# 801 *BLANCHARD*

801 Blanchard Street  
Seattle, WA 98121  
Project # 3037081-LU

Downtown Design Review Board  
2nd Design Review Recommendation Meeting  
10.25.2022

# RESPONSES TO DRB #1 - MATERIAL APPLICATION

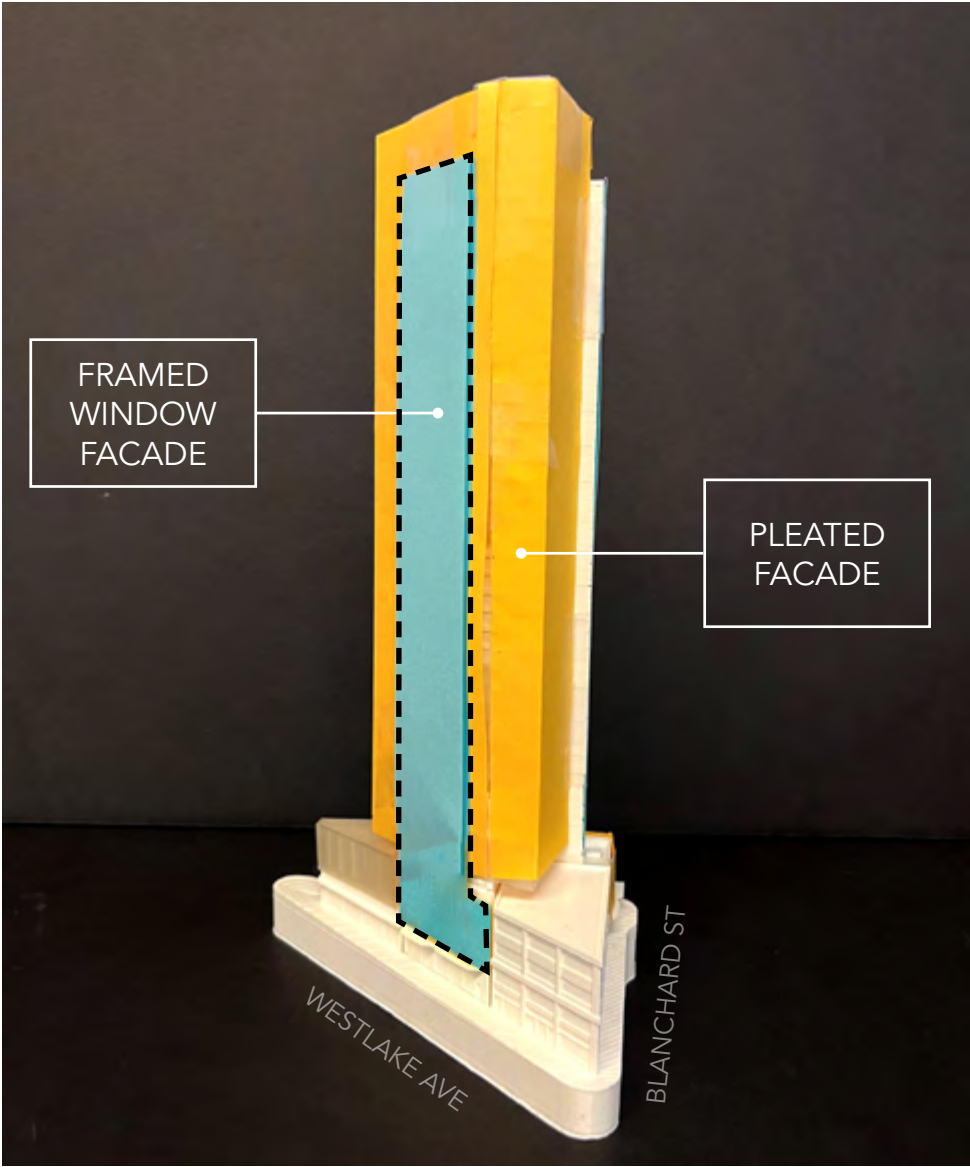
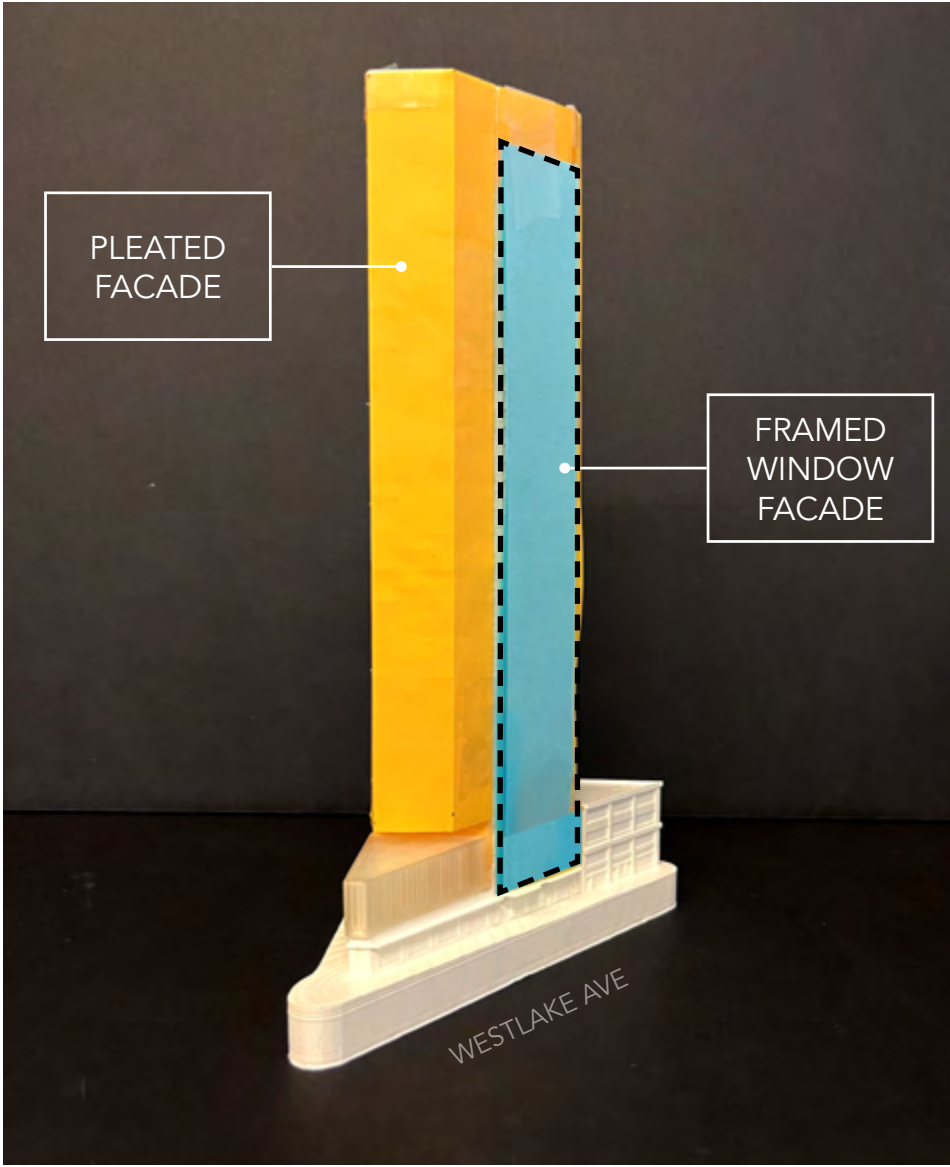
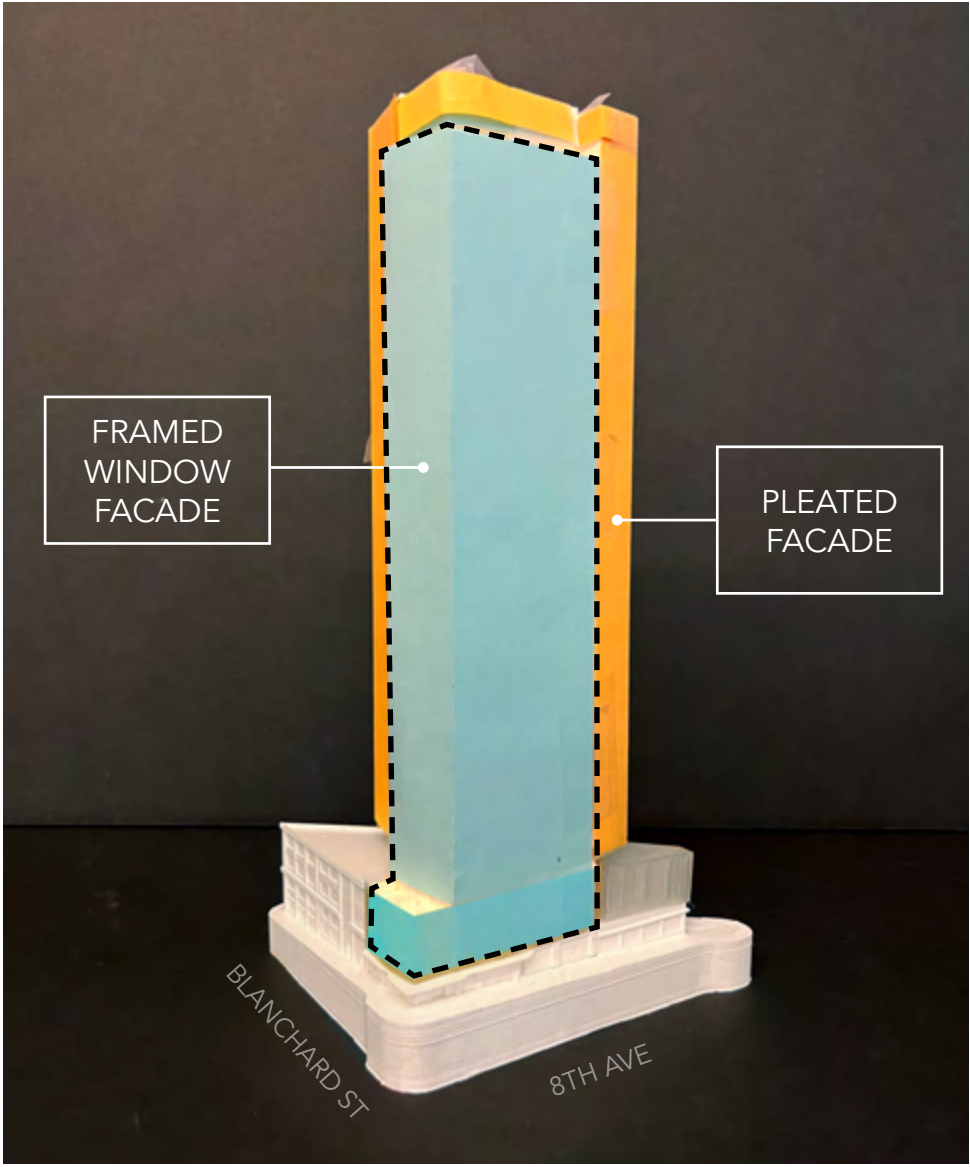
a. The Board appreciated the revised approach to the pinwheel concept since the second EDG meeting, which was pushed further by establishing the “pleated” and flatter “framed window” façade types. The Board, however, was concerned about the transitions between these different façade types and the clarity of the architectural language and requested the project return for a second Recommendation meeting to consider additional information showing how the materiality and detailing have been further developed to successfully express the design concept and mass. (B-4, B-4.3)

**Response:** We appreciate the Board’s comments and suggestions, and have revised our color palette and application to better compliment the “pinwheel” concept. To create more of a distinction between the “pleated” and “framed window” expressions, the podium frames have been revised to be a silvery, white tone, matching the tower above. By doing this, the champagne color becomes isolated to the cantilevered portions, which accentuate the “pleated” language, clarifying the differences in architectural expressions.

# RESPONSES TO DRB #1 - MATERIAL TRANSITIONS

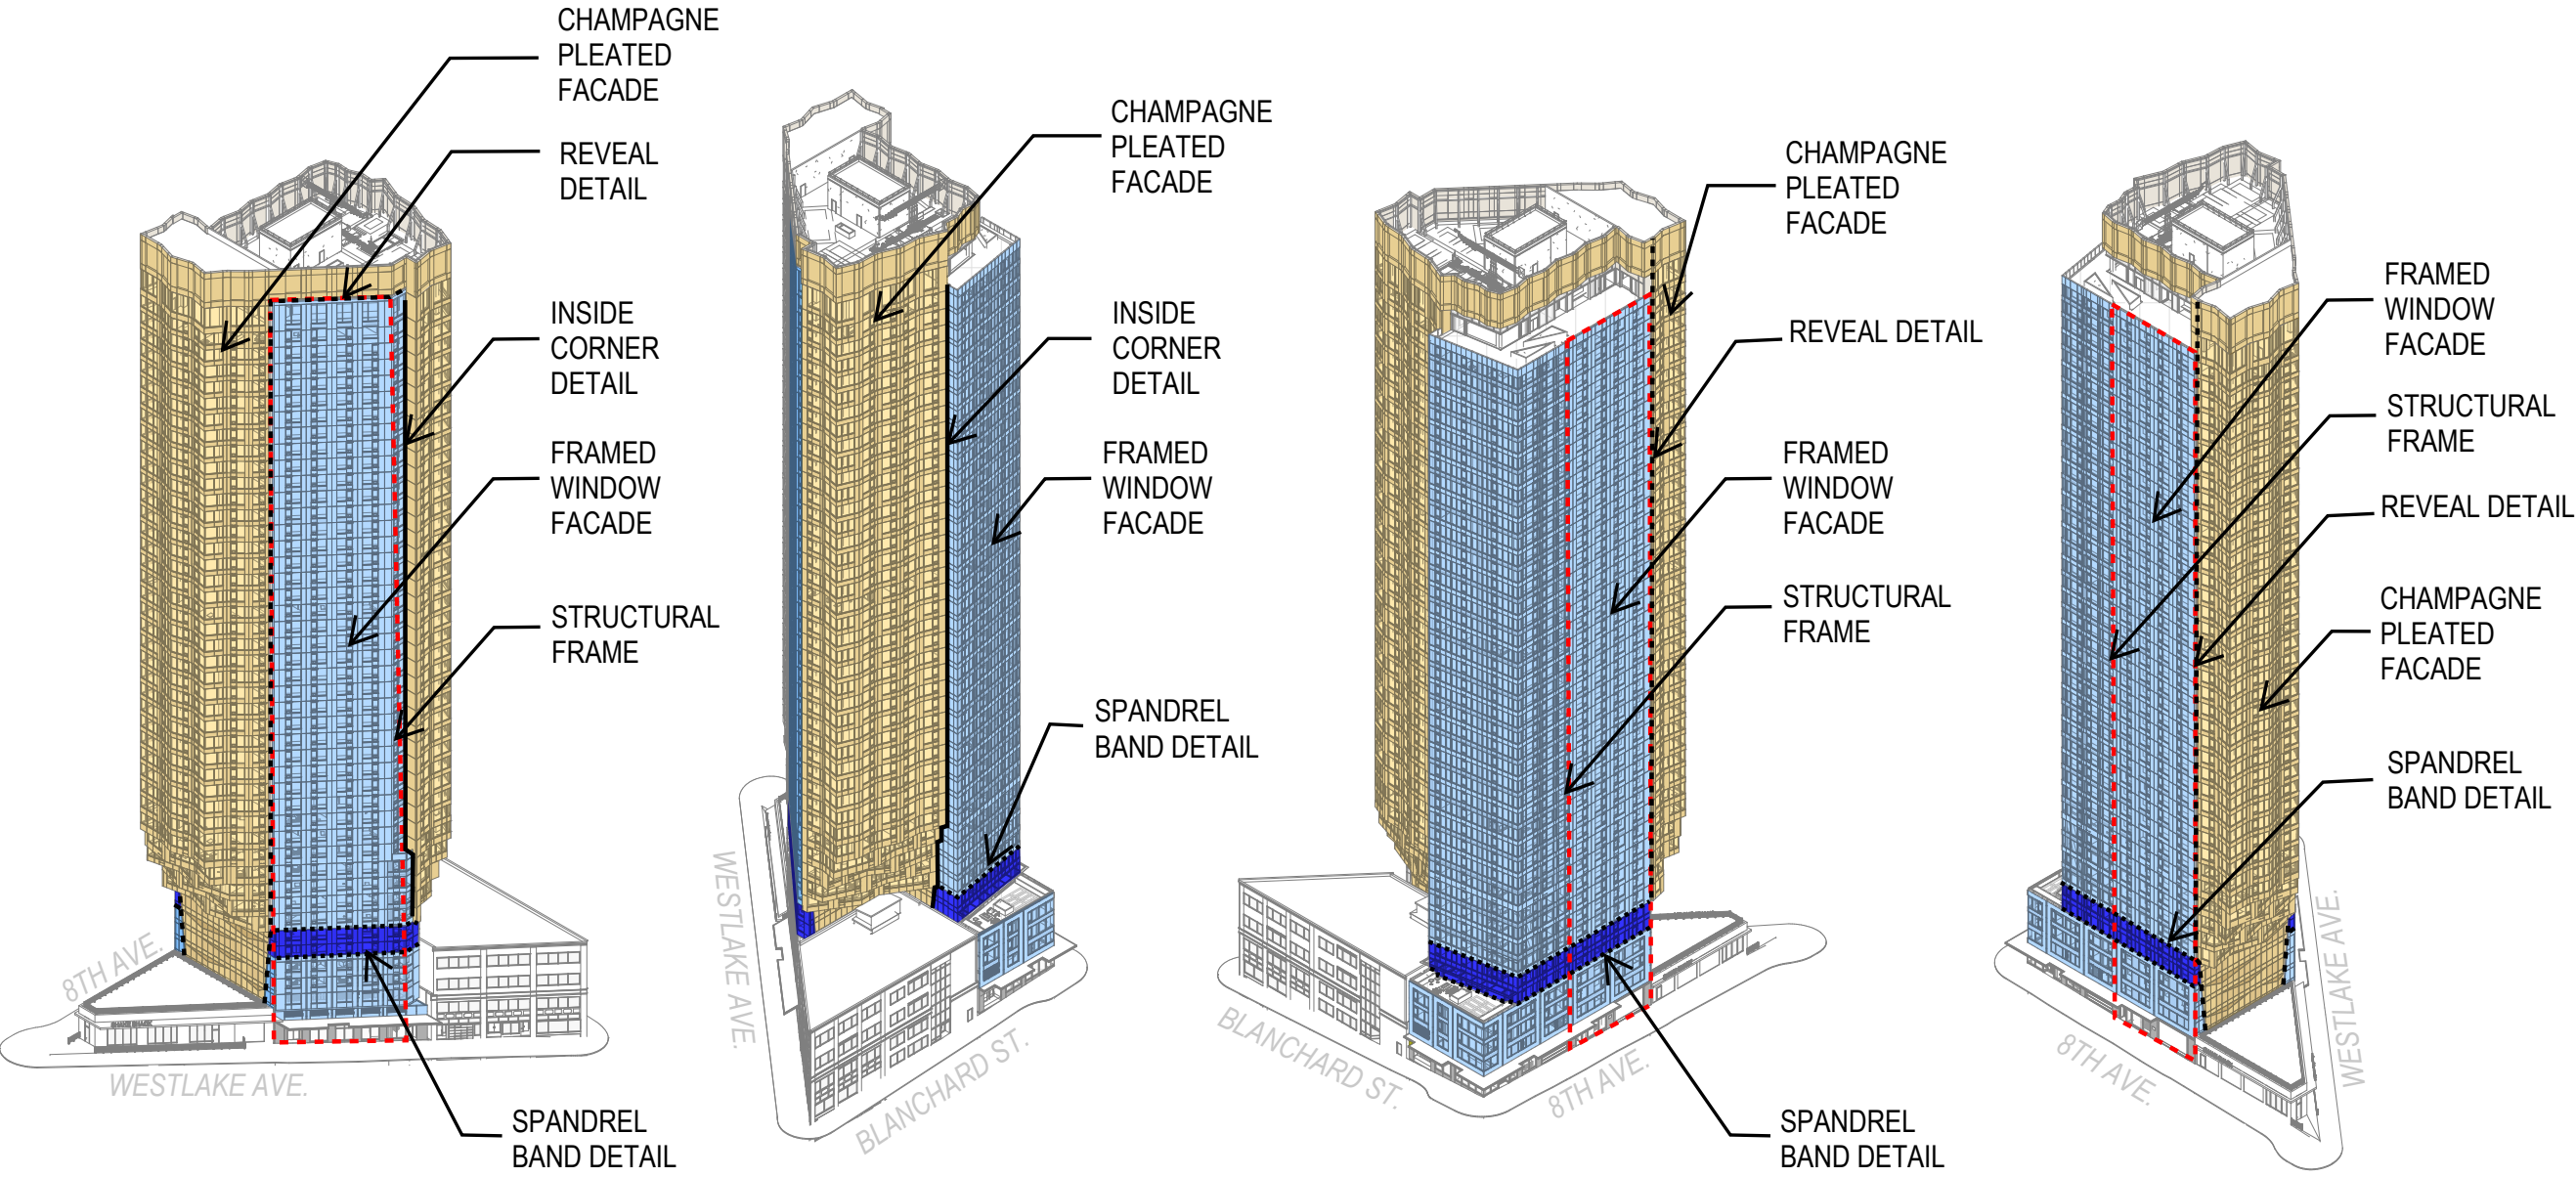
b. The Board was concerned with the lack of unifying architectural details; particularly, the detailing of the transitions between the “pleated” and “framed window” façade types. The Board stated that the detailing of these transitions should be deliberate and distinguish between the different parts of “pinwheel” mass. The Board noted that these transitions could be distinct or blurred, but either way the approach should be consistent on all facades of the building (B-4, B-4.3)

ii. The Board directed further study of the transition between the white-colored “framed window” façade type and the champagne-colored “crown”; particularly, where the transition is coplanar. (A-2, B-4, B-4.3)

**Response:** After re-examining our material locations, we further identified and developed details at intersections. Considering the Board’s recommendations, both vertical and horizontal transitions have been resolved and where appropriate, reveals have been utilized as solutions. These reveals have been uniformly enlarged to be 18” wide and 12” deep, which appears to be more appropriate for the scale of tower and visually more apparent from a distance. We have added transition diagrams to the revised Design Recommendation Booklet.

# RESPONSES TO DRB #1 - STREETSCAPE & LANDSCAPE

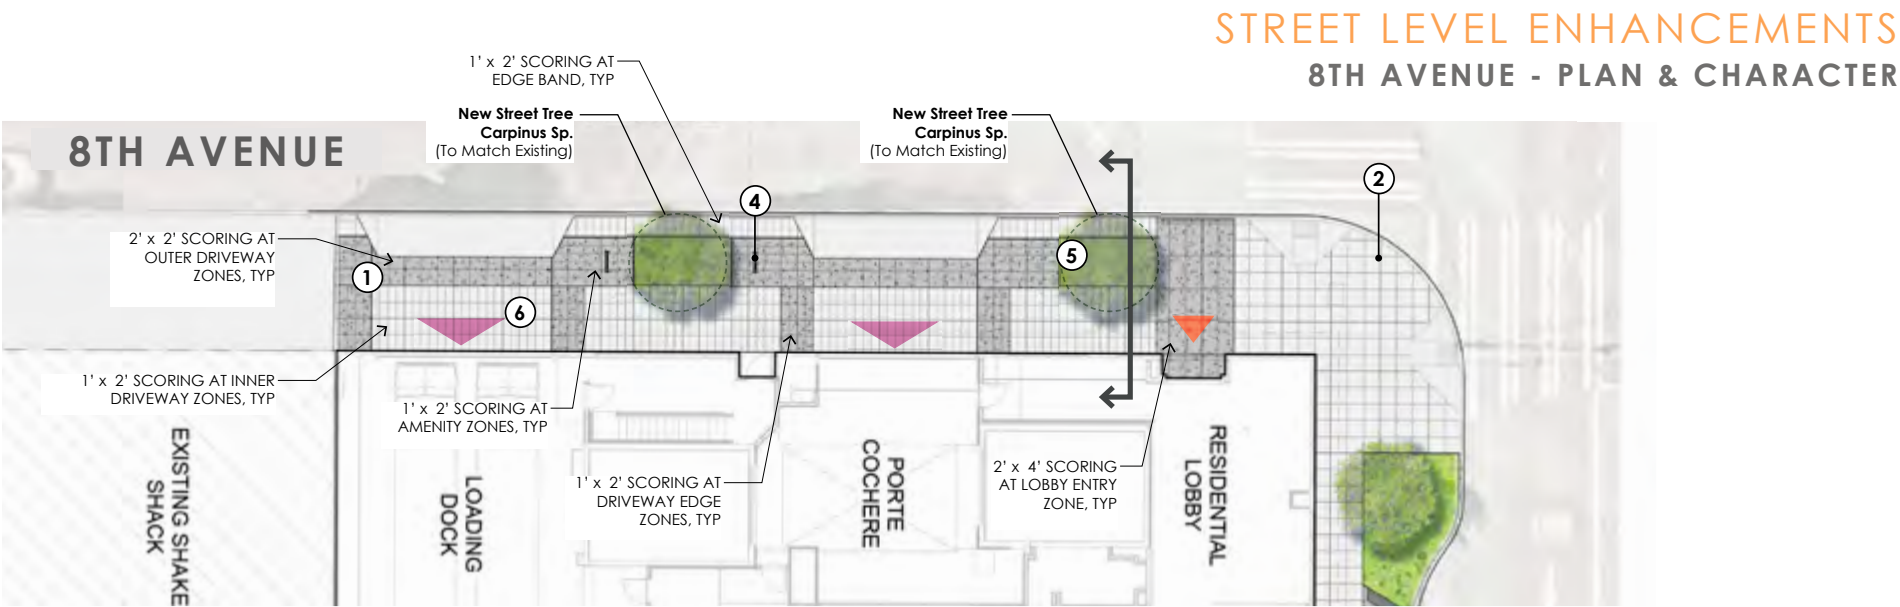
a. The Board supported treating the porte cochere as an exterior lobby and dynamic space for pedestrians, bicyclists, and vehicles. The Board appreciated that the residential lobby connects to the porte cochere via a hallway along the sidewalk edge. (B-4.2, C-1.1, C-1.3)

b. The Board stated the proposed landscape plan was successful – and supported the paving patterns and use of subtle texture to distinguish drive aisles across this sidewalk. (D-2, E-1)

**Response:** Agreed. We consider the porte cochere as part of one cohesive design together with the lobby. Continuity of floor paving, travertine walls, and consistent lighting design are examples of devices used to tie the porte cochere and lobby spaces together. These high-quality finishes will be visible through the open facade and allow for an active and enhanced pedestrian experience along the 8th Avenue.

**Response:** Noted. The paving patterns and use of subtle texture remain as a feature of the sidewalk and help increase safety along 8th avenue.

# DEPARTURE 2: MINIMUM SIDEWALK AND ALLEY WIDTH

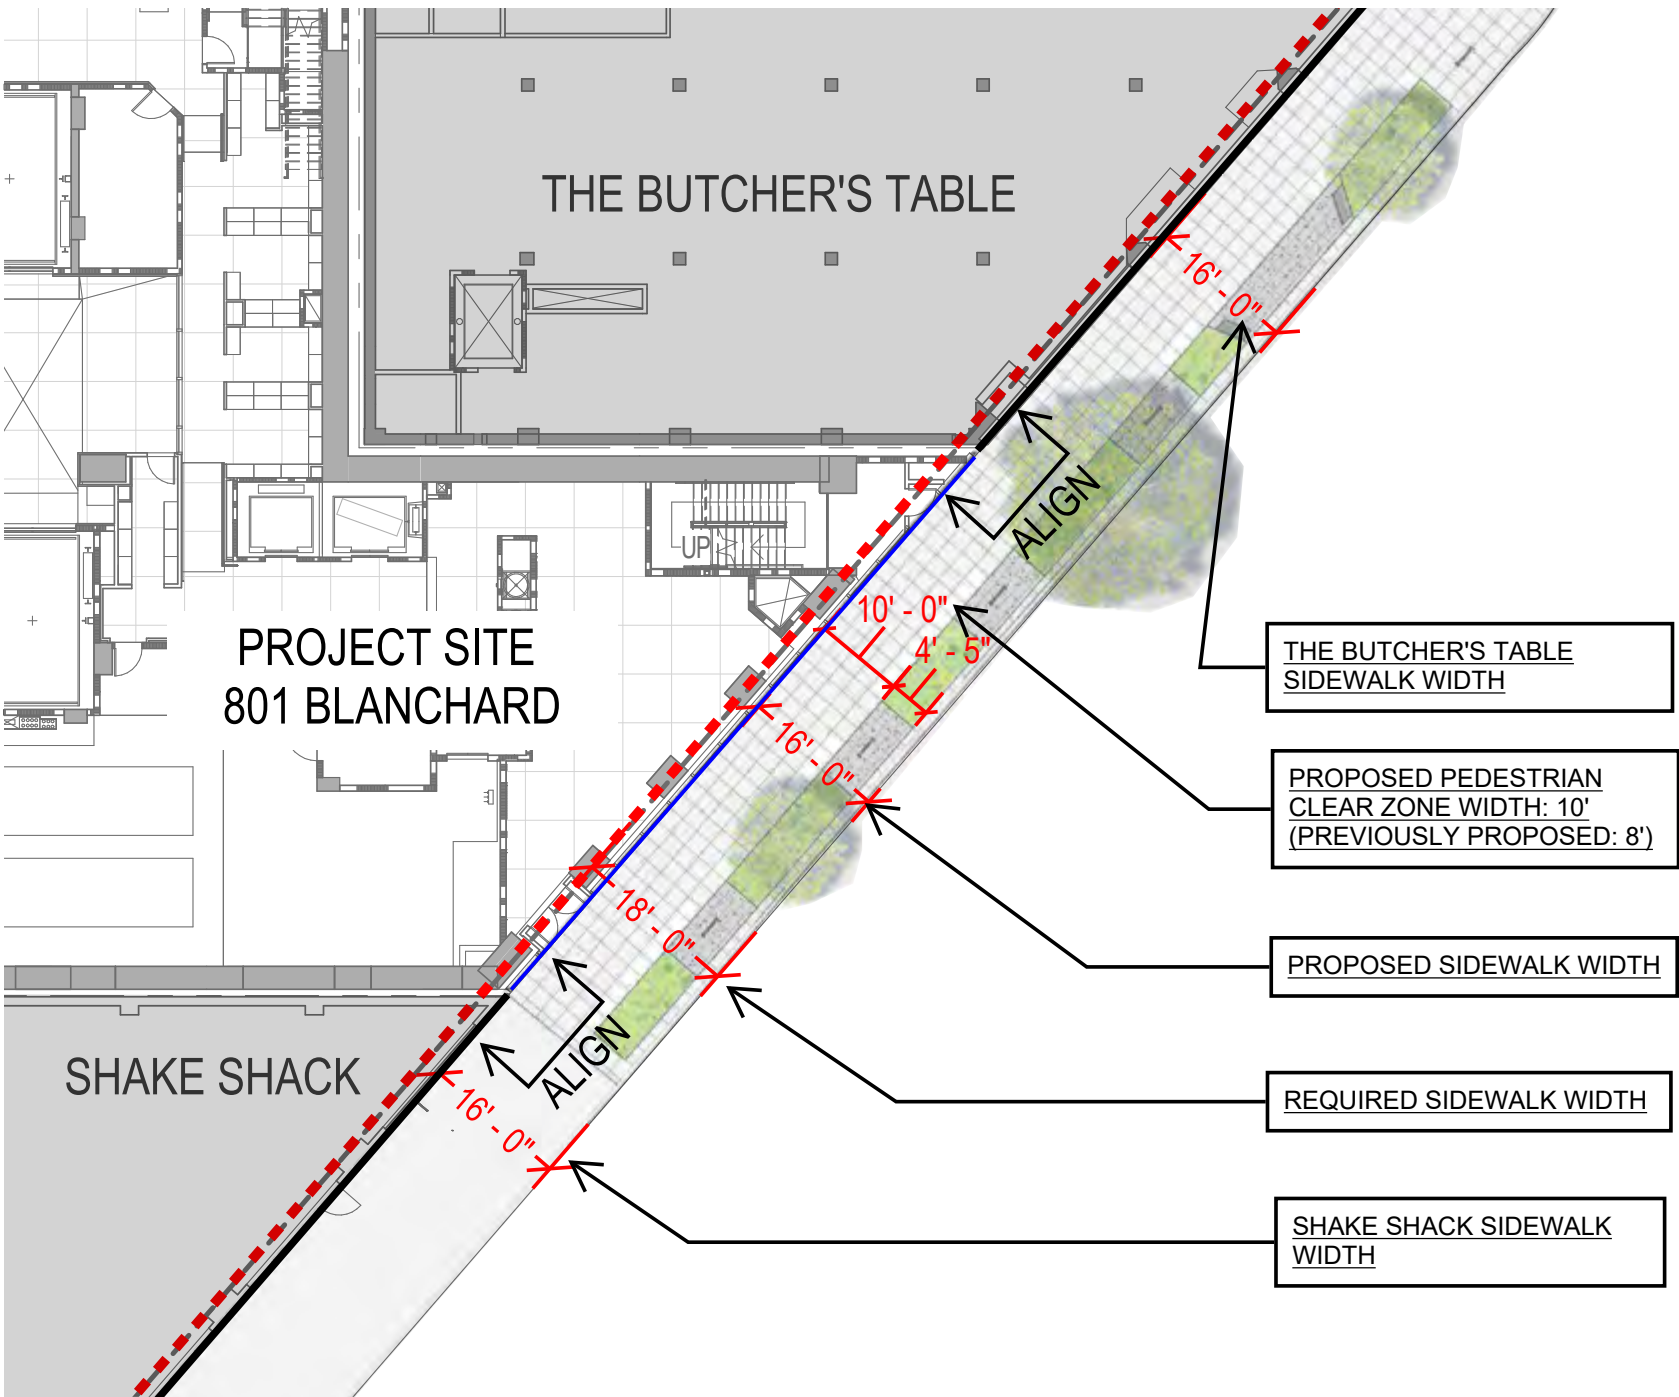
D2	Minimum Sidewalk Width (SMC 23.49.022, Map 1C):The Code requires minimum 18-foot wide sidewalk along Westlake Ave. The applicant proposed a minimum of 16-foot wide sidewalk.  The Board acknowledged SDOT comment, but was inclined to support the requested departure from minimum sidewalk width based on the applicant's design rationale, provided that the applicant maximizes the width of the pedestrian clear zone as encouraged by SDOT. The resulting would have the potential to maintain a strong street edge, while providing sufficient pedestrian volumes. (B-1, B-3)	We appreciate the Board's support and have revised the landscape plan and site plan to provide a 10' wide clear path on Westlake Ave. This results in a strong street edge and gracious pedestrian space, without compromising plantings and other landscaped elements. See page 65 for reference.

We request that the required sidewalk width be the existing sidewalk width of 16’ wide with a 10’ wide pedestrian path, with no additional setback, easement, or dedication.
